**schema 3: revisions to scheme 2**

- REV F 09 Mar 2022 G/M/G  
 The previously approved scheme (scheme 2) is altered to include a number of minor, non-material amendments: the amendments included mostly rationalise the alterations at Rev E
- REV E 06 Sep 2021 G/M/G  
 The previously approved scheme (scheme 2) is altered to include a number of small amendments.
- REV D 15 Jan 2021 G/M/G  
 Planning Application further revised, in response to planning and conservation officers comments.
- REV B 10 Aug 2020 G/M/G  
 Revised Planning Application marked at Revision B
- REV A 05 Dec 2019 G/M/G  
 Original Planning Application marked at Revision A

**PROJECT**  
**The Hoo: Scheme 3**  
**17 Lyndhurst Gardens,**  
**Hampstead, London**  
 Returning a Grand Victorian House to Private Domestic Accommodation NW3 SNU

**DRAWING**  
**Lower Ground Floor Layout**  
**as Proposed**

**DRAWING**  
**Roof Layout**  
**as Proposed**

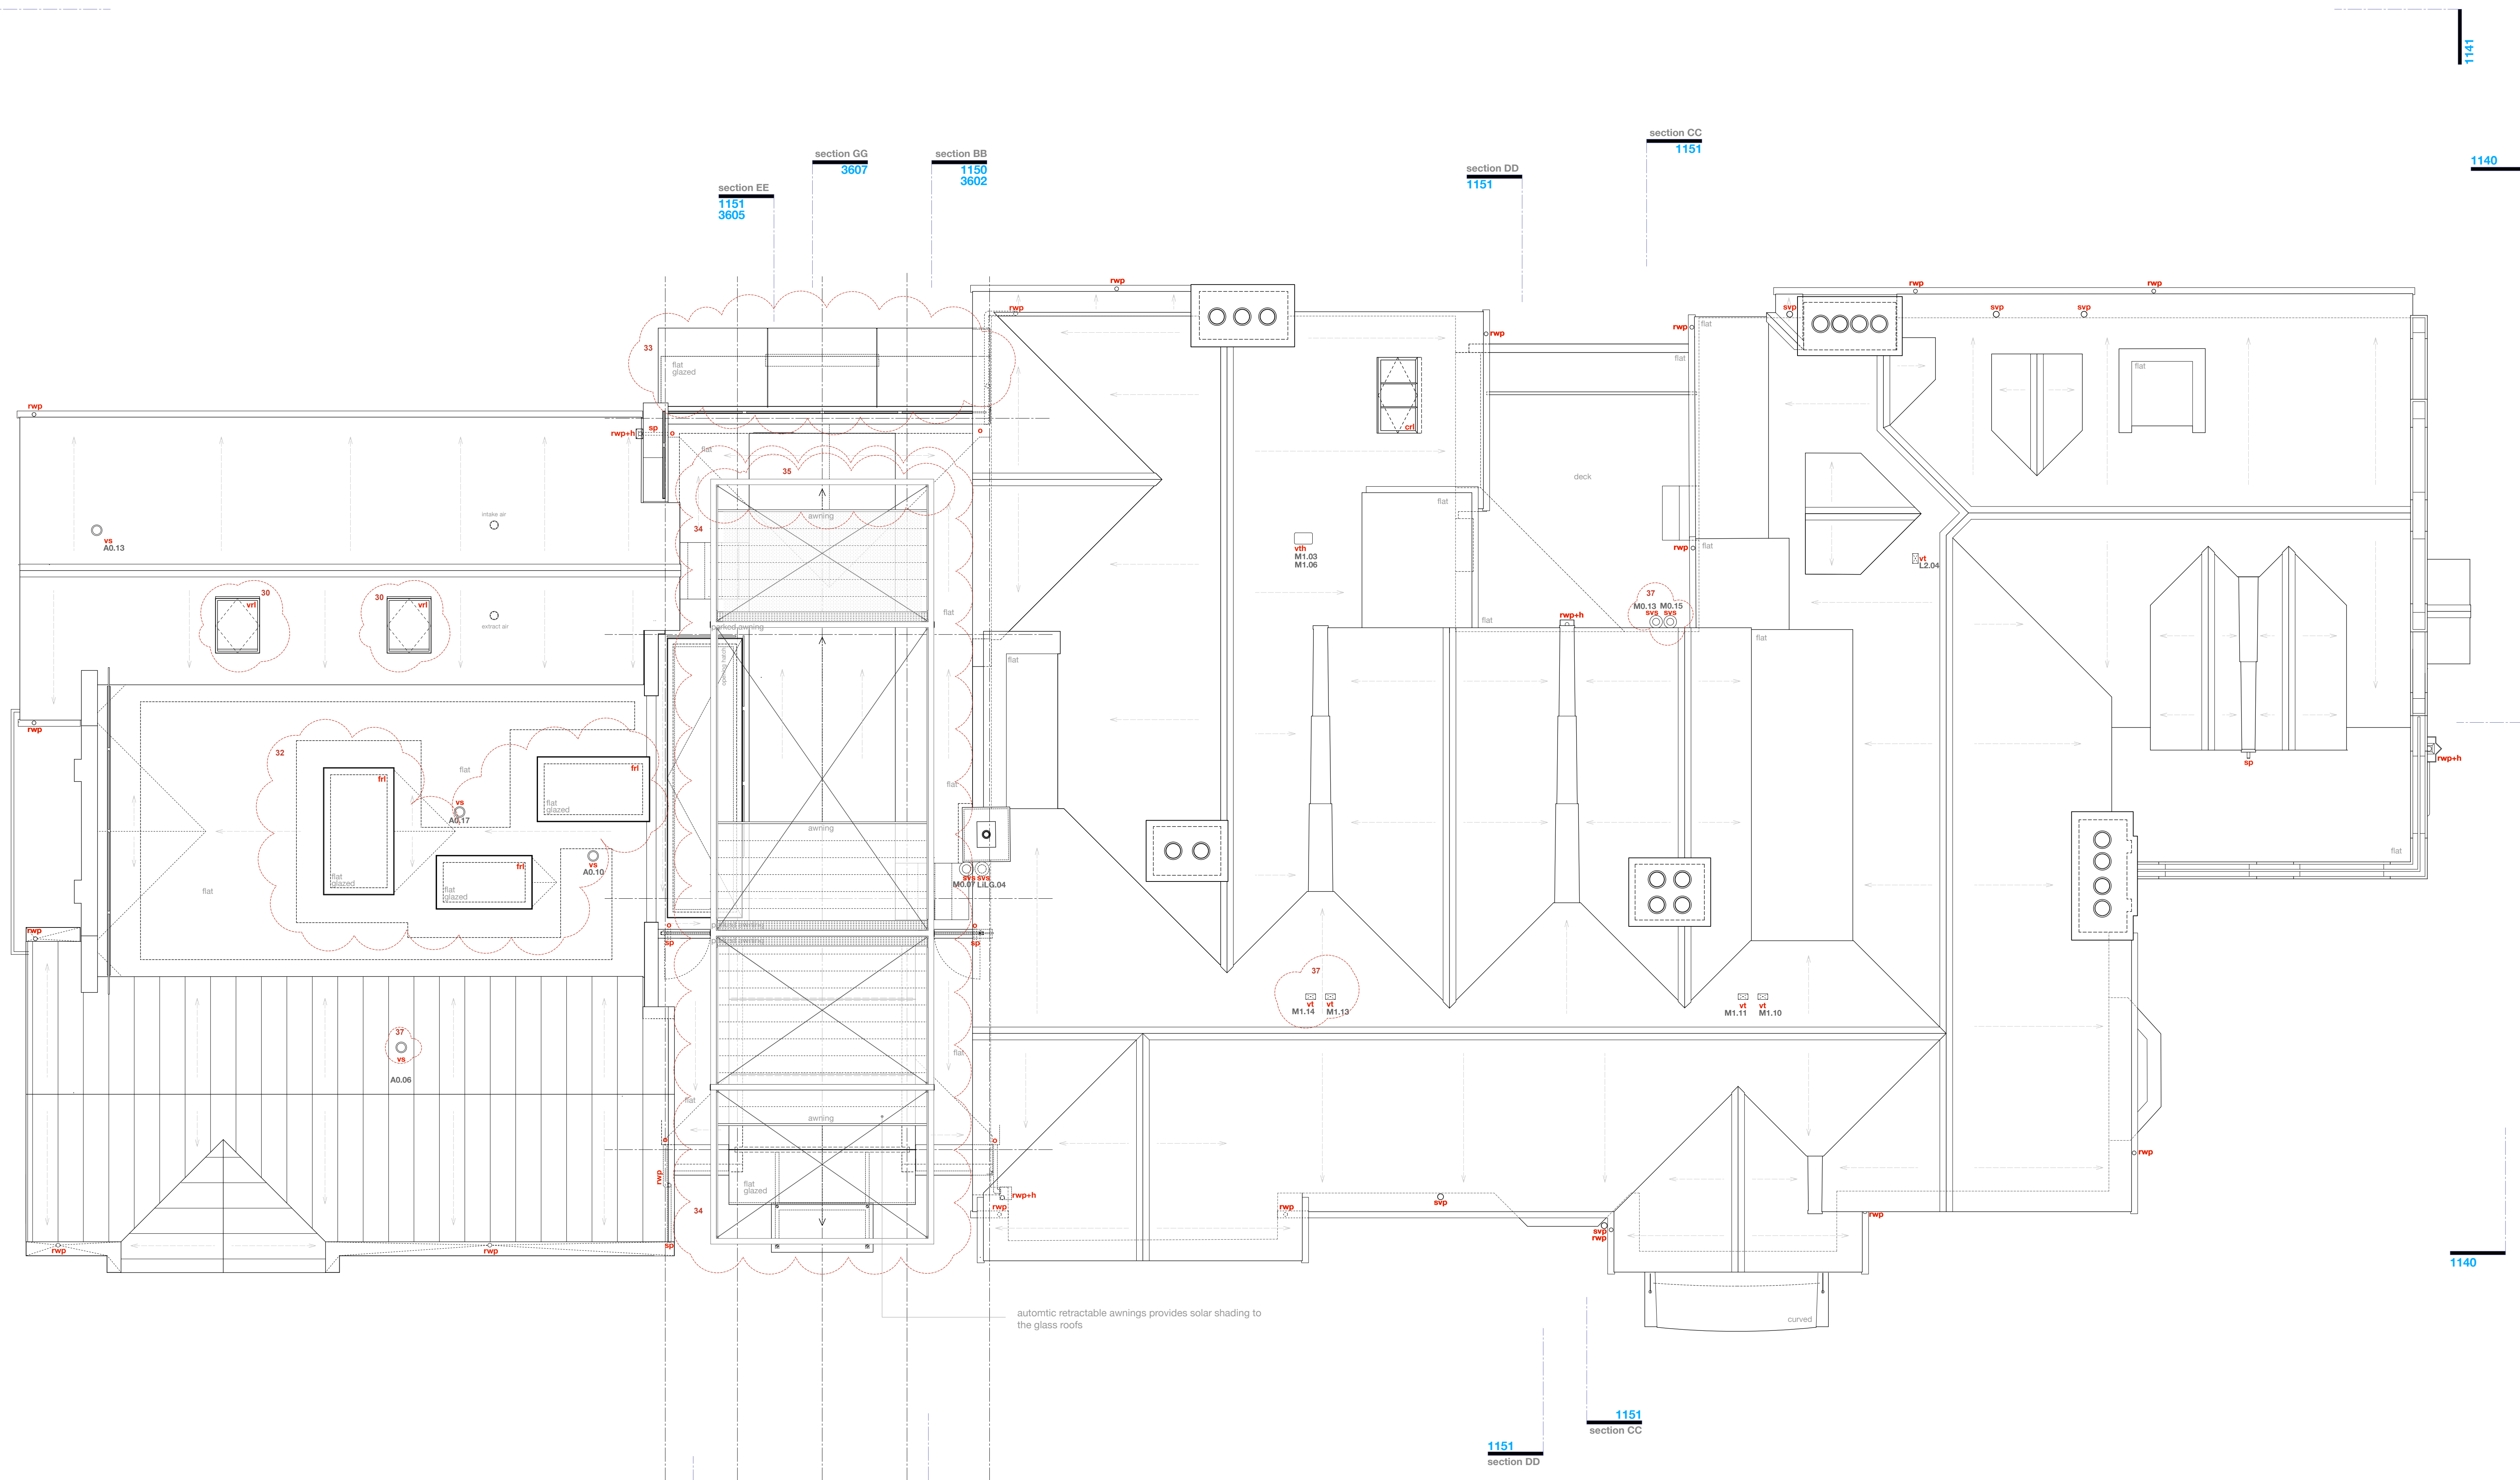
- 30 1907's awning: new velux roof lights providing natural light to bedrooms
- 32 1907's awning: rooflights in flat roof are repositioned
- 33 flat glassed rear elevation omitted in favour of projecting glass box with glass lid
- 34 design of awning frame has evolved, cross bracing included
- 35 length of framework supporting awning is shortened by 900mm from the room
- 37 all new service penetrations, flues, vents, extracts etc all positions marked and types and colours/materials identified

DRAWING  
**South and East Elevations**  
**as Proposed**

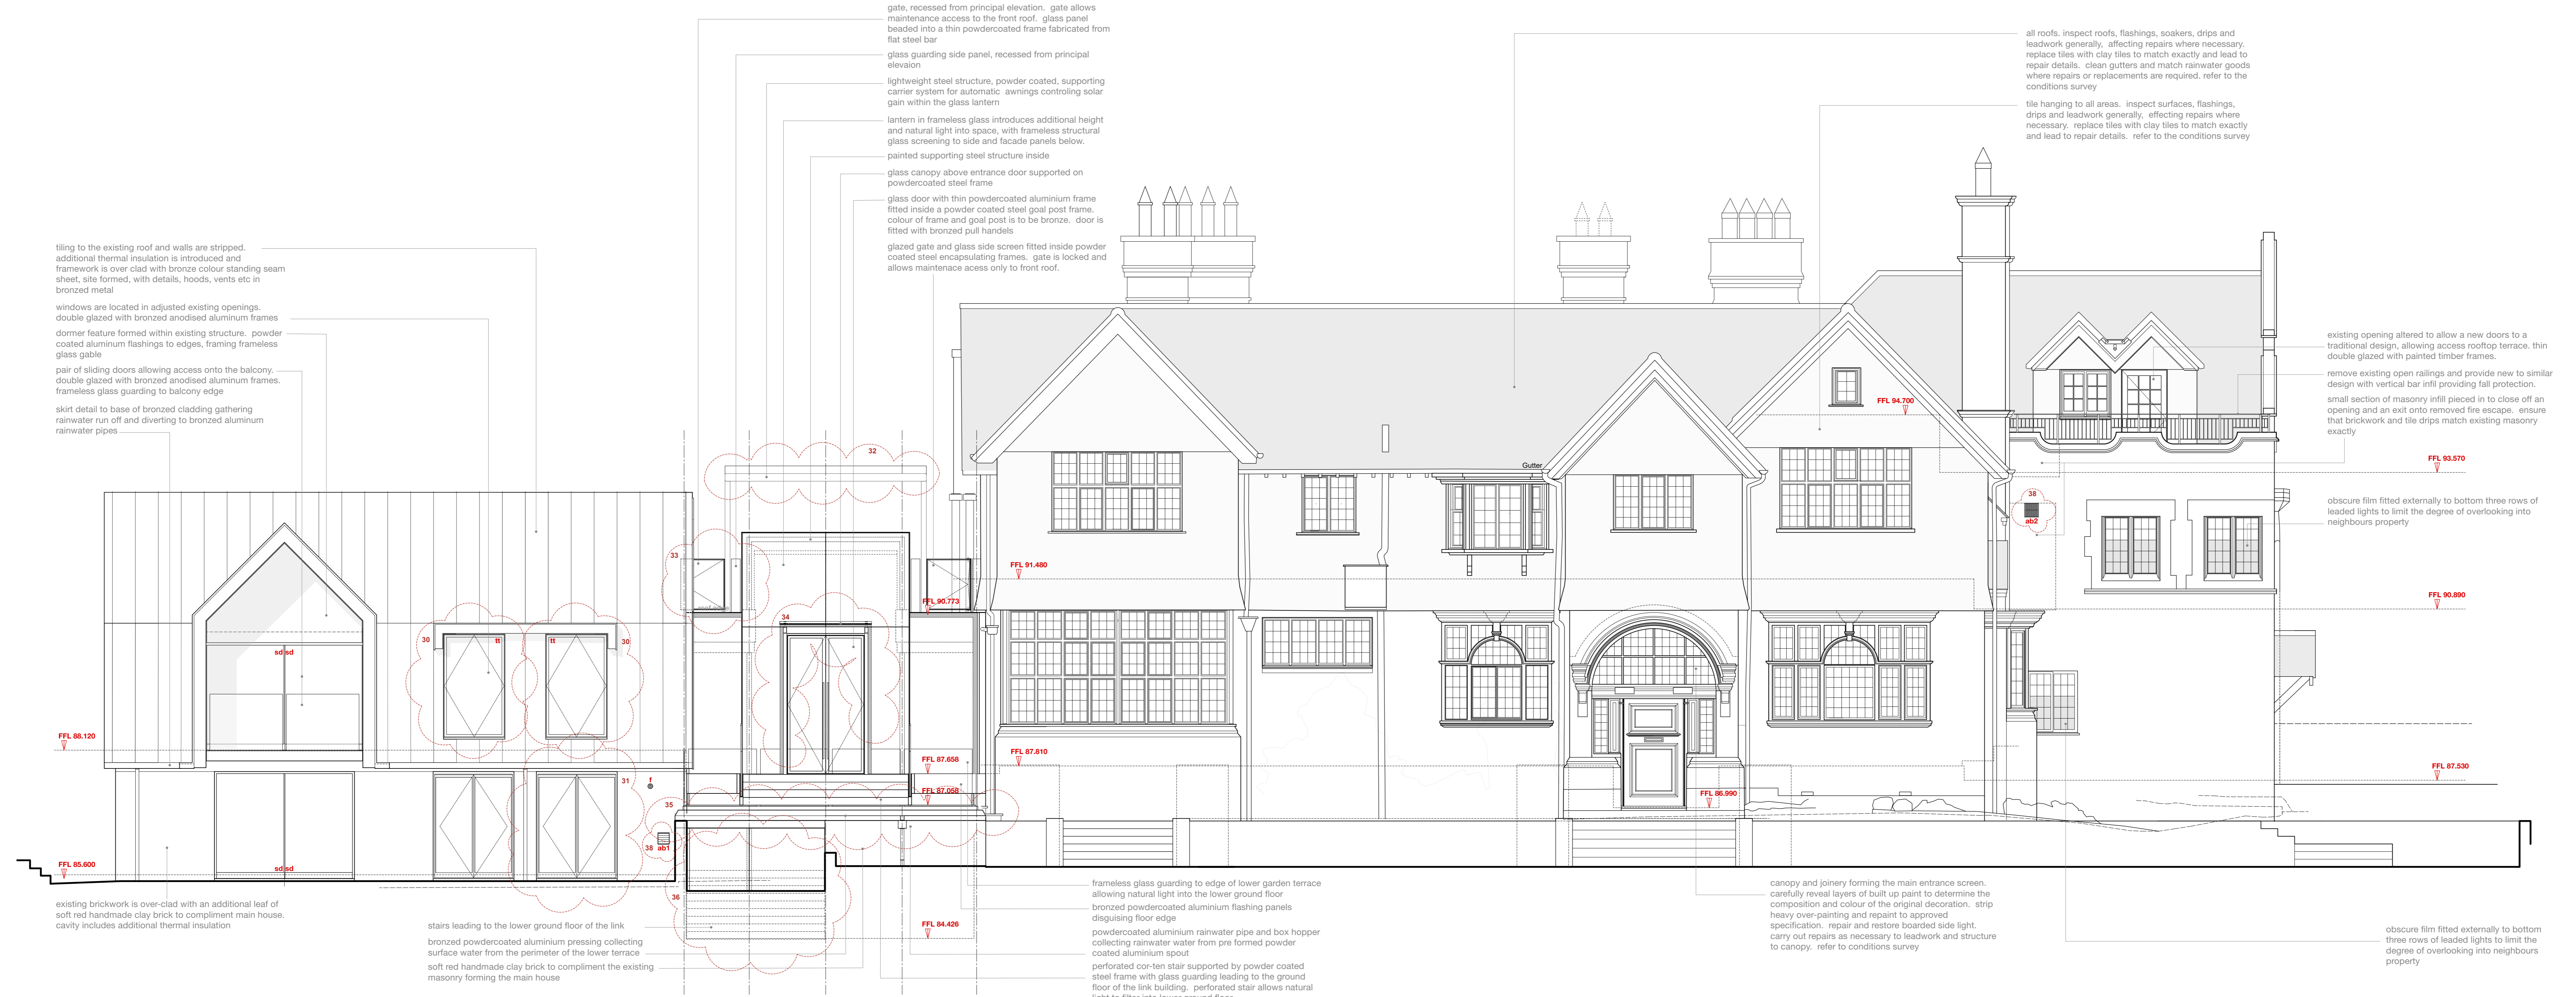
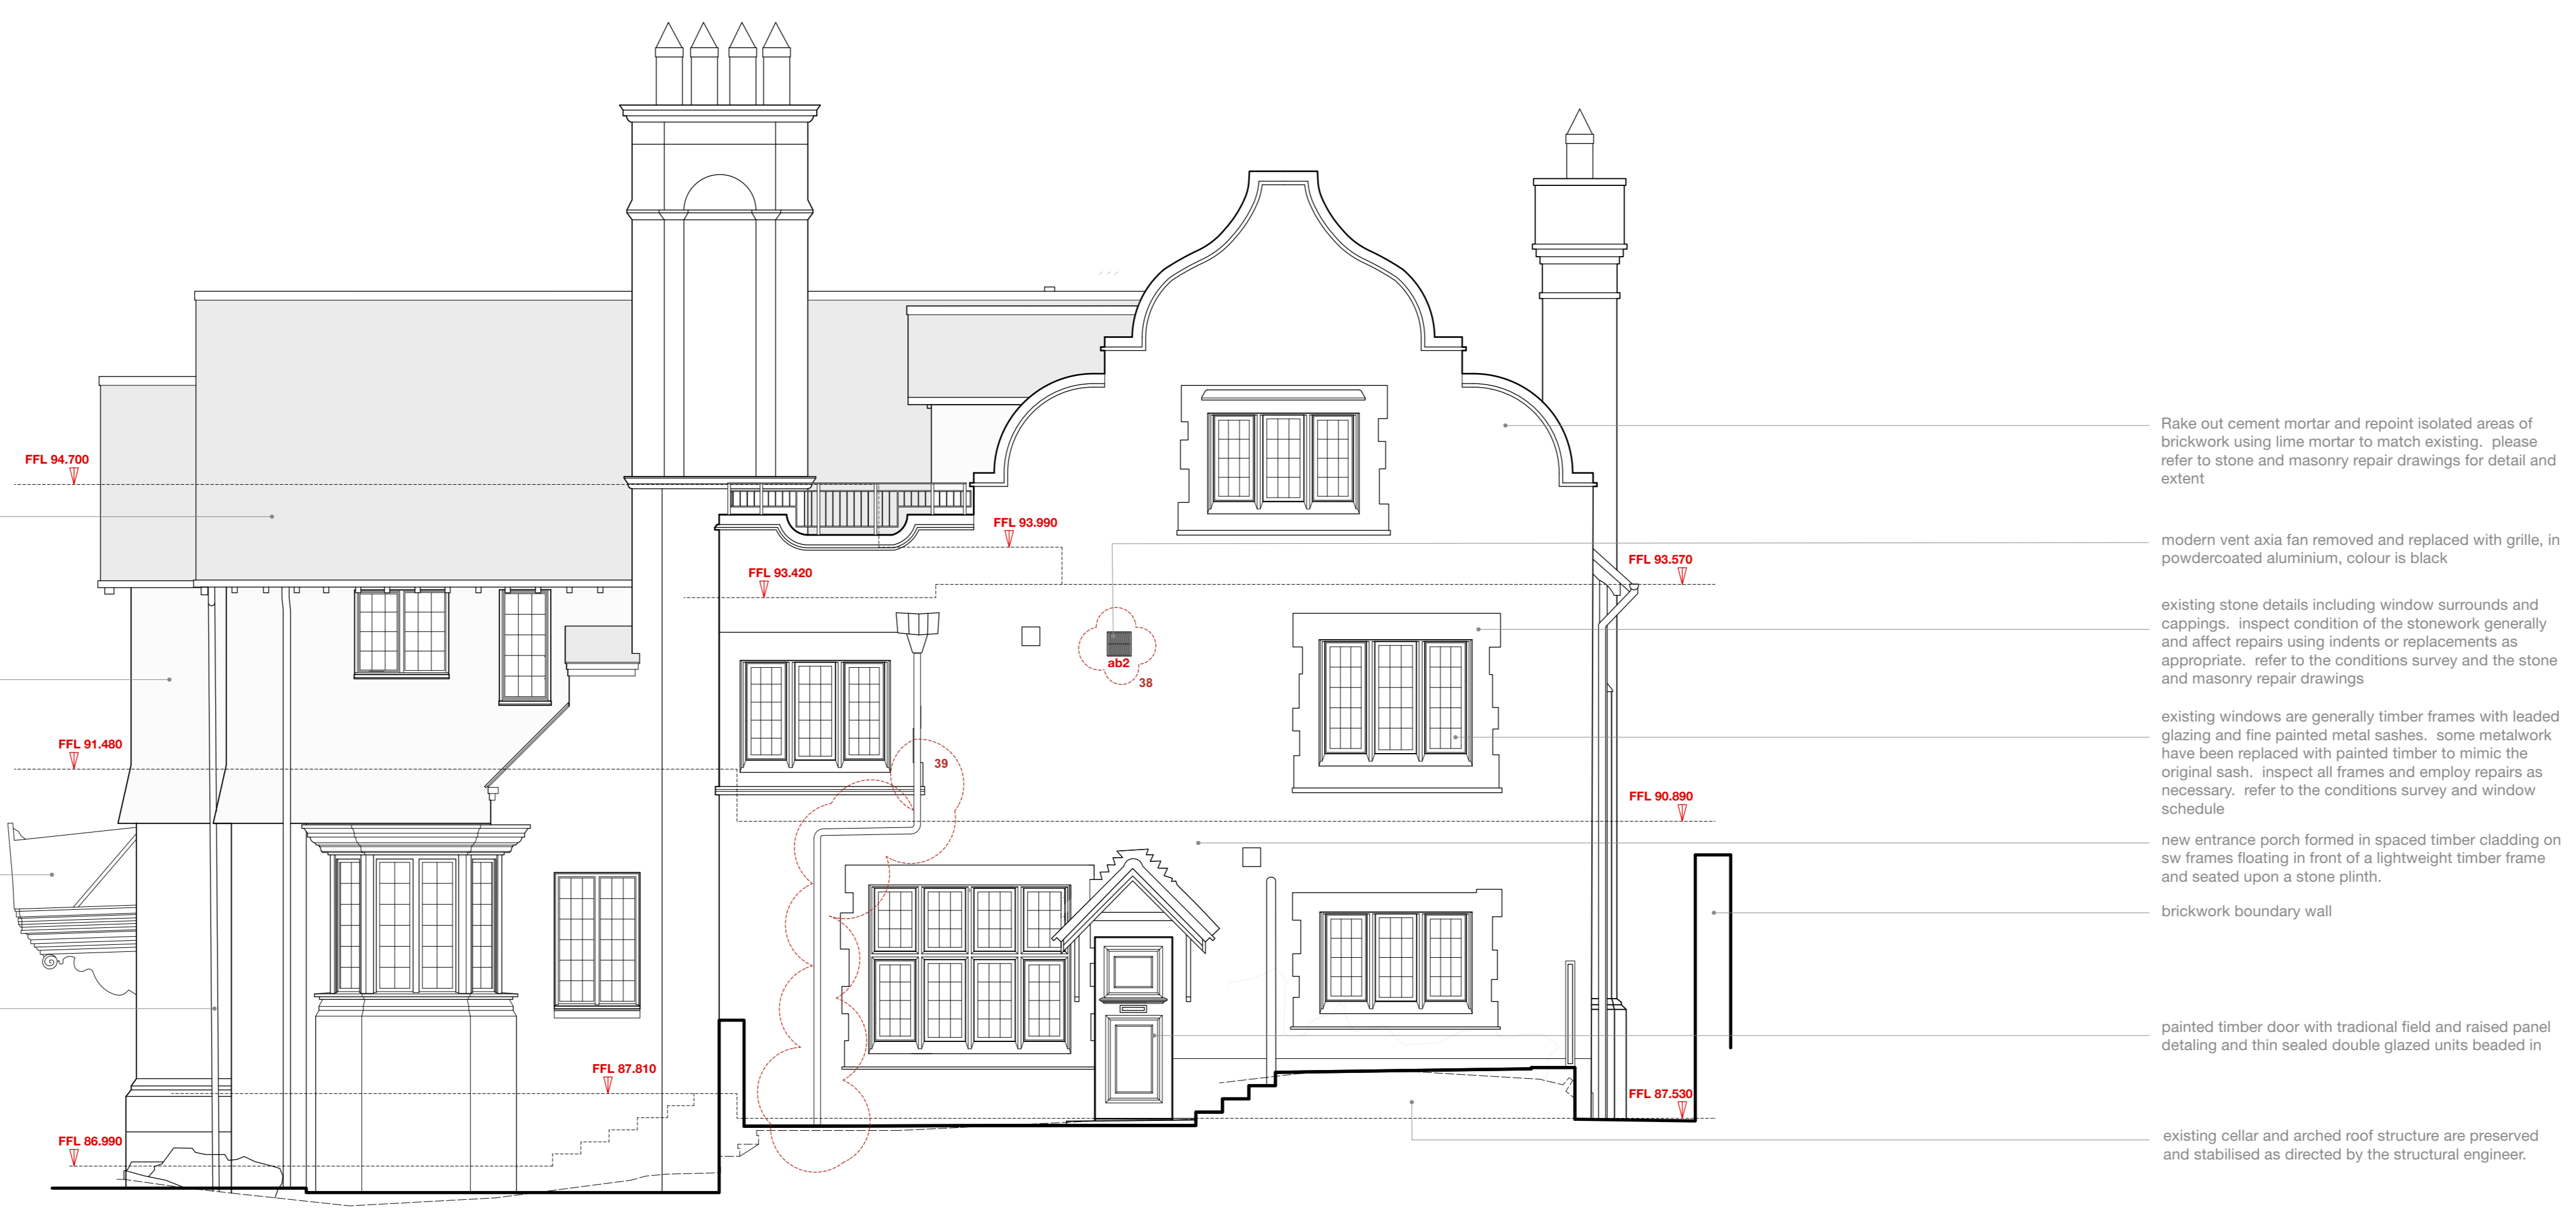
- 30 1980's annexe: openings become wider
- 31 1980's annexe: formerly a window opening, expanded to become a french door
- 32 the average frame is filled by 300mm to improve visibility from bedrooms and to ensure sufficient headroom below parked carport

- 33 air use rooflight (replaced) omitted in favour of a low profile glass hatch. solid construction is therefore removed from the elevation and left adjacent to the lantern as accessed through a locked glass gate instead.

- 34 door opening and protective glass canopy. frame is required to stabilise glass elevation
- 35 level of terrace is filled by a single step to ensure minimal head height below. profile of lower terrace widened, tapered edge skirting to the sill detail of the original building

- 36 staircase and opening are widened to the west
- 37 new service penetrations including flues, vents, extracts etc: all positions marked and types and colours materials identified

- 39 existing rwp re-routed to simplify junctions adjacent to the porch. original hopper is retained.
